PD Modification Application: MM 25-0810

Zoning Hearing Master Date: January 26, 2026

**Hillsborough
County Florida**

Major Modification 25-0810 proposes a **2nd Option to Pocket E** to allow up to 1,200 residential homes as a residential option in Pocket E as approved in the Comprehensive plan Amendment to the Energy Innovation Park. Additional revisions include modifying the acreage of Pocket I, which is a buffer pocket, to account for the reduced buffer area if Pocket E is developed with the residential option; modifying Pocket J to redesignate as open space and not a buffer; and modify conditions of approval to reflect the new development option. The applicant also proposes to allow hotels and motels in Pocket "A".

8.2 Proposed Site Plan (page 2 of 5)

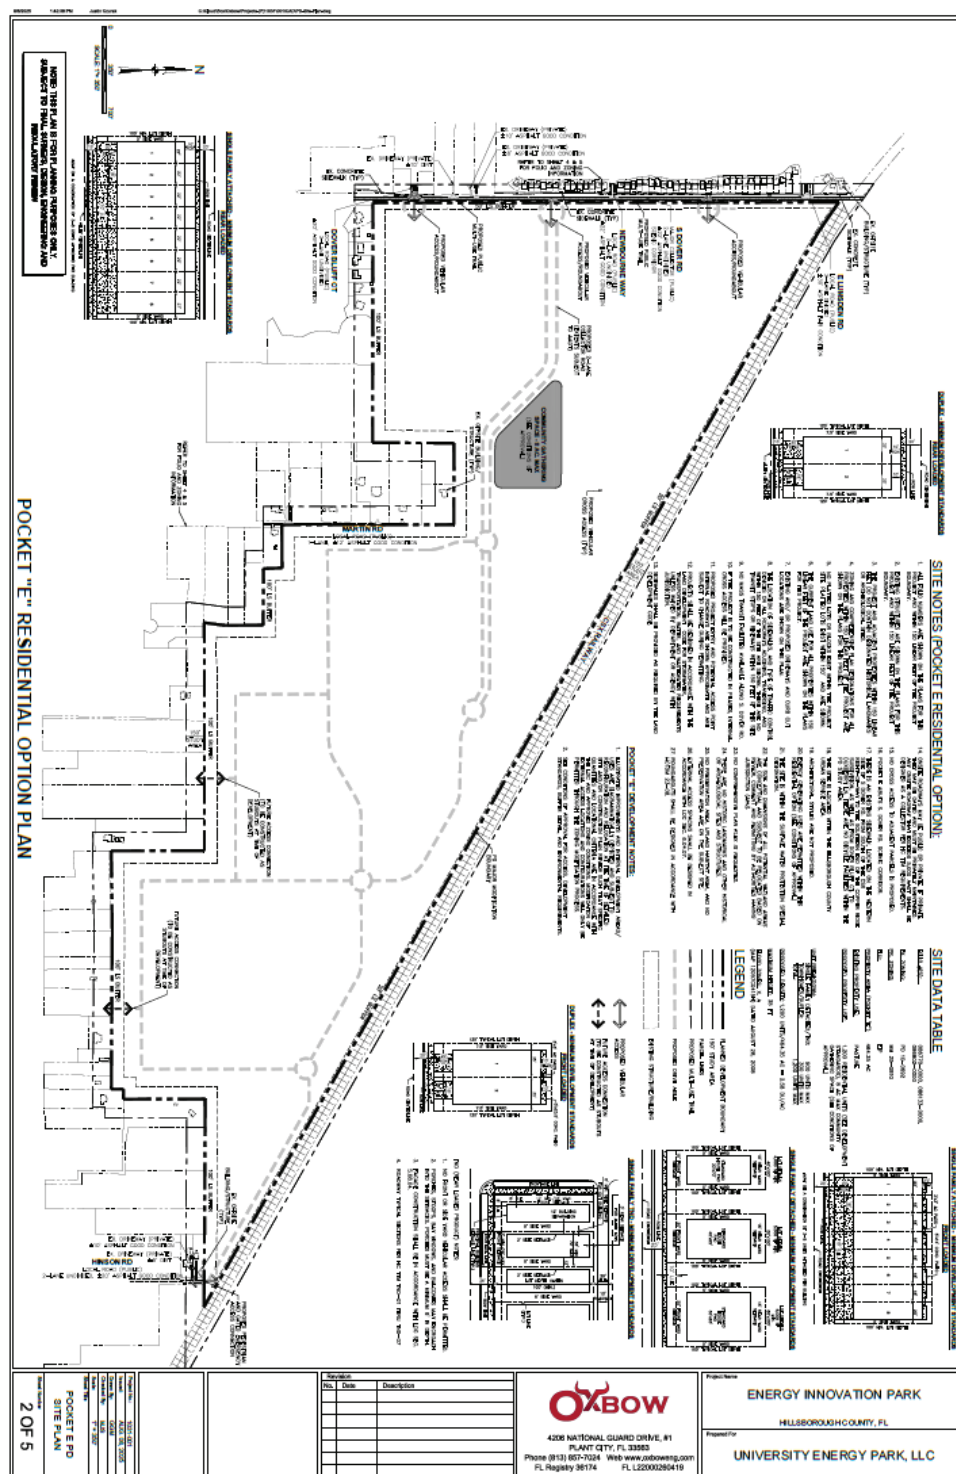
Prior to Site Plan Certification the following shall be amended:

- On Sheet 2 of 5:
 - Add an asterisk for each typical lot layout heading to add with a footnote which states “*Minimum setbacks shall be increased where required, see zoning conditions for additional information.”;

- Remove all dimensions from the edge of lot to roadway centerline from all typical lot layouts (e.g. remove the 20-foot edge of lot to road centerline dimension from the Rear Loaded Duplex typical lot layout). Staff notes these conflict with typical section standards.

- Revise the typical lot layout label which states, “SINGLE FAMILY DETACHED - MINIMUM DEVELOPMENT STANDARDS” to instead state “SINGLE FAMILY DETACHED (FRONT OR SIDE LOAD ONLY) - MINIMUM DEVELOPMENT STANDARDS”.

- Revise the typical lot layout label which states, “SINGLE FAMILY TND - MINIMUM DEVELOPMENT STANDARDS” to instead state “SINGLE FAMILY TND (REAR LOAD ONLY) - MINIMUM DEVELOPMENT STANDARDS”.

- Revise the TND (Rear Loaded Product) note 4 to either delete the note or revise to match the proposed conditions of approval.
 - Revise the Single-Family TND lot layout to label the alleyway as one-way, revise the label stating “20’ Alley” to instead state “20’ Min. Alley”, and delete the dimension/label stating “10’ roadway”, and all a label at the front of the building which states “Roadway”.

- Delete notes 11 and 26. Staff notes that the PD is site plan controlled and only minor deviations are permitted at the time of site/construction plan approval without a PD modification.

- Revise Note 15 to add the statement “Access stubouts shall be provided as shown.”
 - Revise Note 14 to add the statement “Notwithstanding the above, internal roadways shall comply with Policy 4.1.4 of the Hillsborough County Mobility Element, which will be determined at the time of plat/site/construction plan review.”
